**Walton County
The Grove**

**Change Proposal #7 –
Removal of East Wall in
Umpire Room - Building C**

043 - Building "C" - Umpire Room (Elimination of East Wall)

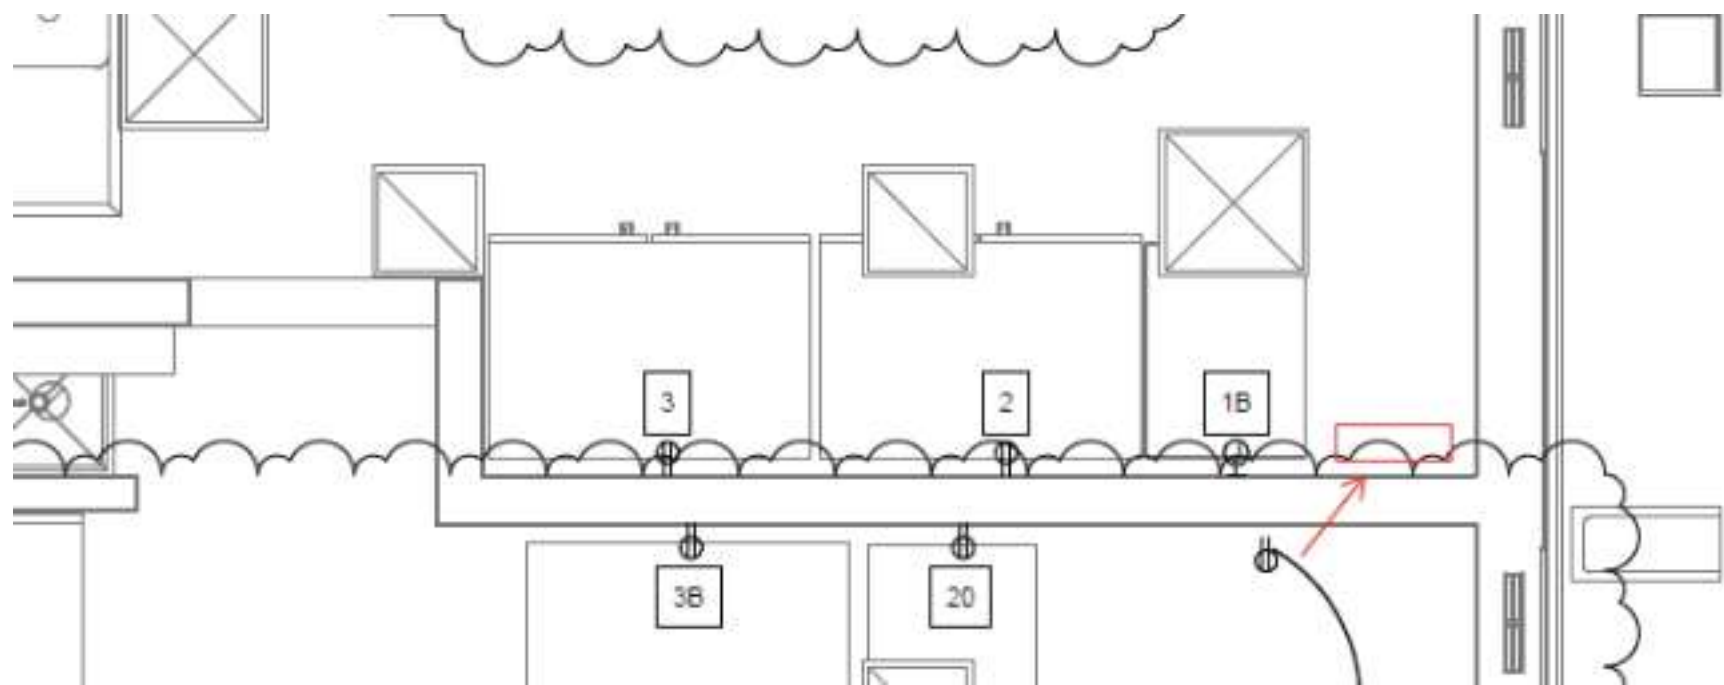
Building C - The design team has decided to remove the East wall in the umpire room. Please update the drawing sheet (A2.01C) to reflect this change.

Additionally, the umpire room was to originally have a sealed concrete floor finish. However, since it will now be adjacent to the pantry, which has an epoxy floor and base finish, would you like to change the umpire room to epoxy floor and base as well, or should it remain as originally specified?

Also, please provide the relocation of the carbon monoxide detector at the eliminated wall. The carbon monoxide detector near the concession roll up door has no source of power.
